ADDENDUM NO. 4

STADIUM LIGHTING

LITTLE JOB #612-12353-02

Hueneme High School

PROJECT NO. 6121235302
 ISSUE DATE 09/04/2020
 REFERENCE ED-200 (AD2-E1)
 DRAWING # AD4-E1

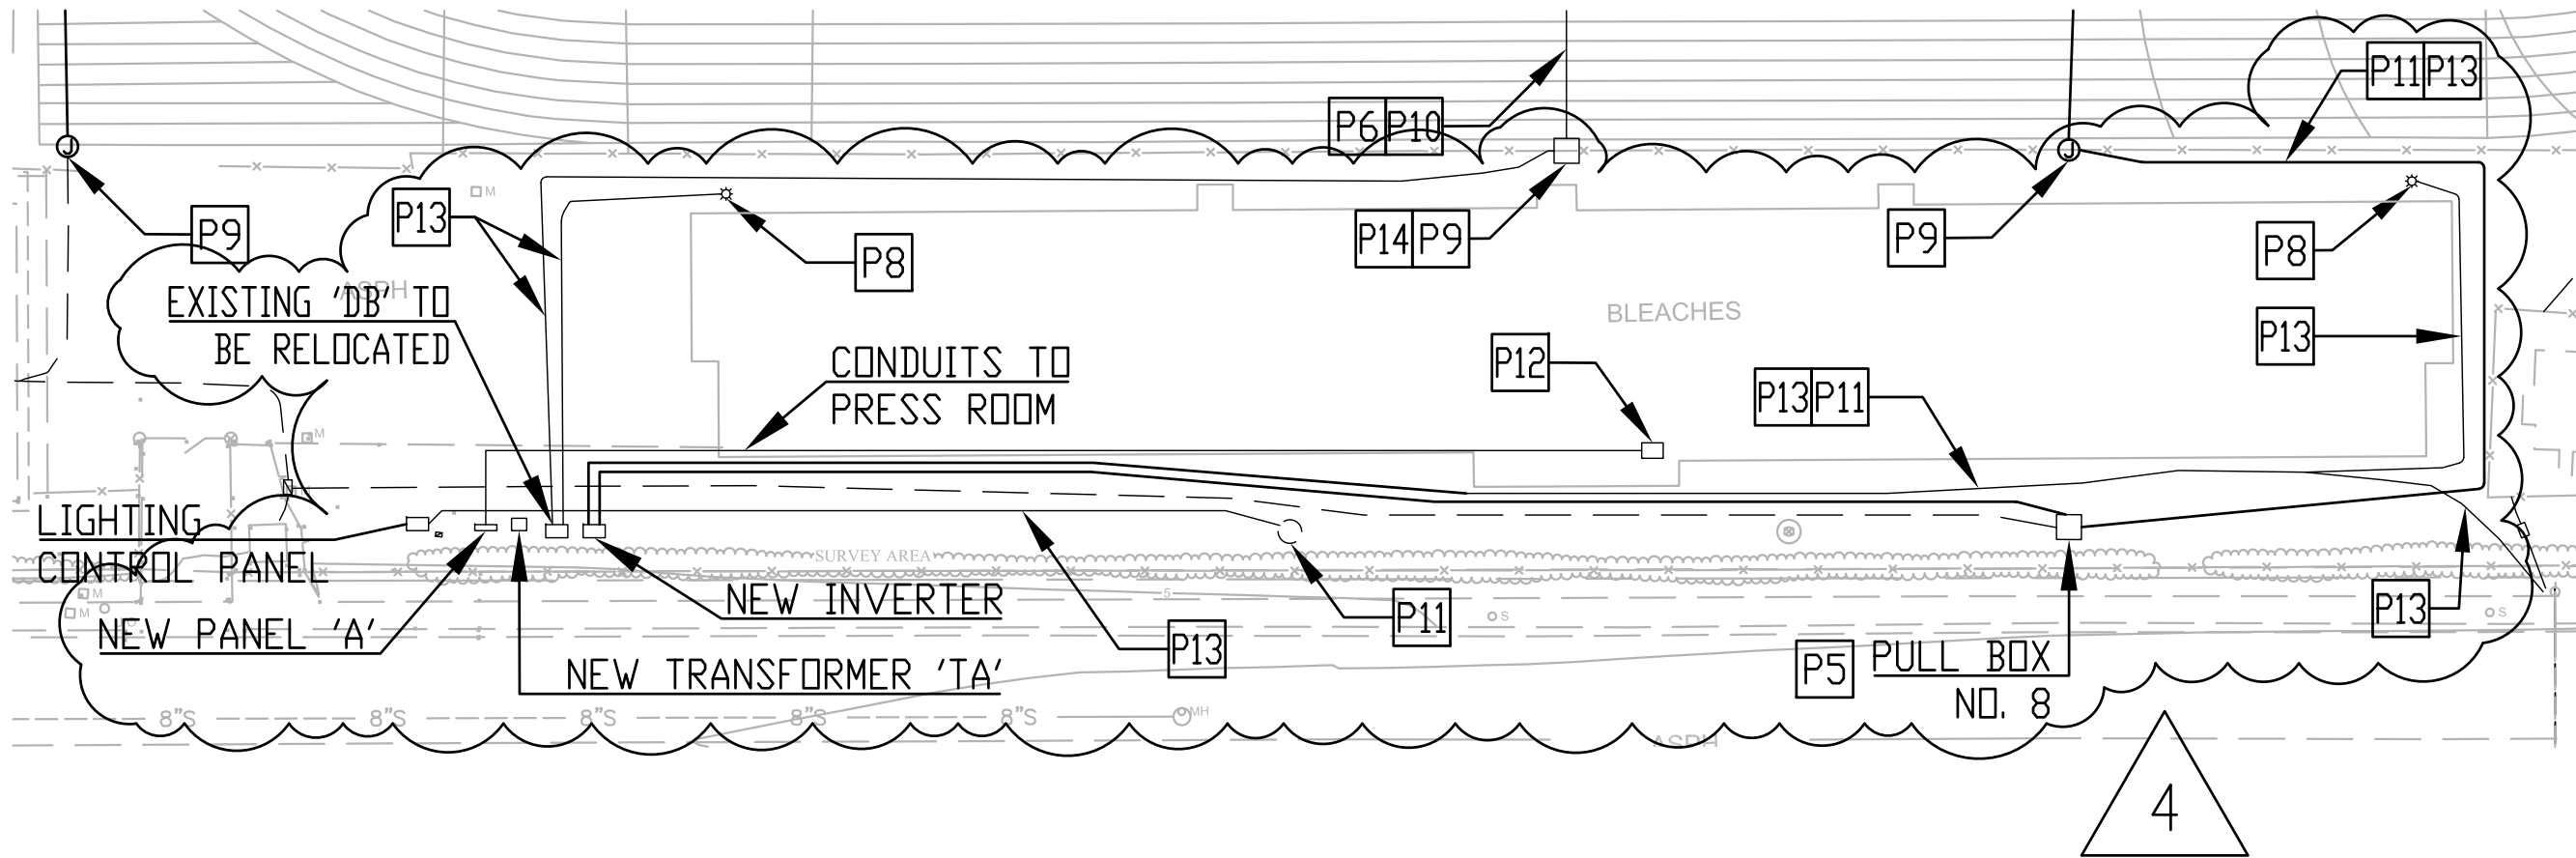
- 1.1. The following revisions and/or clarifications shall be made to the Bidding Requirements and Contract Documents. Revise and amend the Documents for the above named project in accordance with this Addendum. The bid shall reflect these addendum changes and each bidder shall make reference in their bid to this addendum.
- 1.2. All Bidding Requirements and Contract Documents shall apply to this addendum as originally indicated in the applicable portions of the contract documents, unless otherwise modified by this addendum.
 - 1.2.1. Addendum No. 1 issued on August 07, 2020.
 - 1.2.2. Addendum No. 2 issued on September 16, 2020.
 - 1.2.3. Addendum No. 3 issued on September 25, 2020.
- 1.3. GENERAL CLARIFICATIONS
 - 1.3.1. None.
- 1.4. CHANGES TO PREVIOUS ADDENDA
 - 1.4.1. Addendum No. 2, dated September 16, 2020
 - 1.4.1.1. Drawing AD2-E1: Replace with Drawing AD4-E1 attached.

1.4.1.1.1. Note revised note P6.

- P5** NEW PULL BOXES (24"x36") SHALL BE INSTALLED TO REPLACE PULL BOXES #7 & #8. PULL BOXES SHALL BE BURIED 24" BELOW GRADE ENCASED IN CONCRETE
- P6** NEW CONDUCTORS/CONDUITS TO BE BURIED 24" BELOW GRADE ENCASED IN CONCRETE. SIZING AND QUANTITIES OF NEW CONDUITS AND CONDUCTORS SHALL BE VERIFIED BASED UPON EXISTING.
